ASHA Consulting (Pty) Ltd

HIGHLANDS CENTRAL WEF, AMENDMENT APPLICATION: HERITAGE COMMENT DEFF REF NO.: 14/12/16/3/3/1/1958

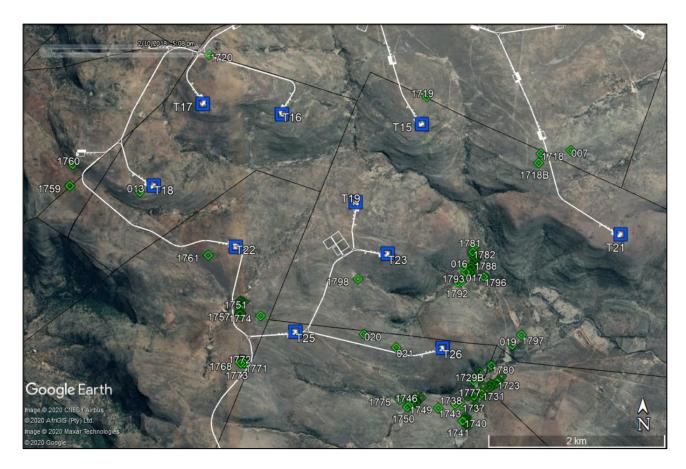
Due to (1) the relatively minor nature of the proposed changes from the heritage perspective, (2) the nature of the cultural landscape and (3) the nature and distribution (both known and expected) of heritage resources found on site, it is found that all existing impact assessment ratings as shown in Tables 5, 6 and 7 of Orton (2018) and Table 7.1 of Almond (2018) must continue to apply. No changes to any of the impact assessment ratings are needed.

Similarly, because the changes are relatively minor, they do not have any bearing on the expected cumulative impacts which, for all heritage aspects, are still expected to be as shown in Tables 14, 15 and 16 of Orton (2018) and described in Section 7.3 of Almond (2018).

Aerial view of the proposed Highlands Central WEF showing the following:

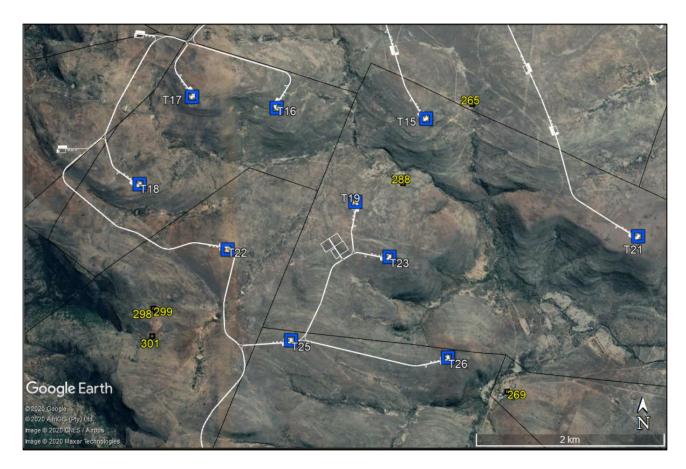
- Turbine locations blue numbered squares
- Facility layout white lines (note that the adjoining Highlands North WEF is also included but its turbines are not shown)
- Heritage resources (numbered green diamonds excluding fossils)
